UNITED STATES PATENT AND TRADEMARK OFFICE

| APPLICATION NO. | FILING DATE | FIRST NAMED INVENTOR | ATTORNEY DOCKET NO. | CONFIRMATION NO. |
|---|-------------|----------------------|---------------------|------------------|
| 10/601,789 | 06/24/2003 | Norio Kimura | 2003-0865 | 9516 |

DETAILED ACTION

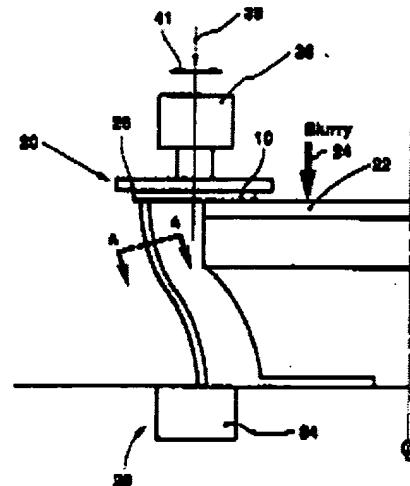
Watanabe et al. teaches polishing apparatus, which can control the attitude of the top ring with respect to a surface of a turntable of a polishing apparatus.

It would have been obvious to one of ordinary skill in the art, at the time the invention was made, to modify the invention of Lebel et al. with the attitude control mechanism as taught by Watanabe et al. to provide a uniform polishing surface pressure across the entire polish surface.

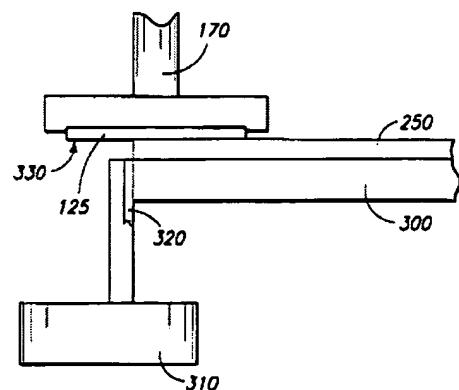
Lenkersdorfer discloses all of the limitations of claims 40 and 41, i.e., a polishing table (300) having a polishing surface (250), a substrate carrier (170) having a lower surface for holding a substrate (125) and bringing the substrate into contact with said polishing surface, a liquid supply nozzle (not shown), water nozzle (320) to spray the wafer, and a film thickness measurement device (310) for determining an end point of the

polishing and being positioned at an outer peripheral portion of the table, except for disclosing an attitude control mechanism for keeping the lower surface of the substrate carrier parallel with the polishing surface and a nozzle providing water to the pad.

Providing nozzle to wet the pad and attitude control mechanism to uniformly polish the wafer are obvious modification in view of Osterheld and Watanabe et al. as indicated above in section 3.
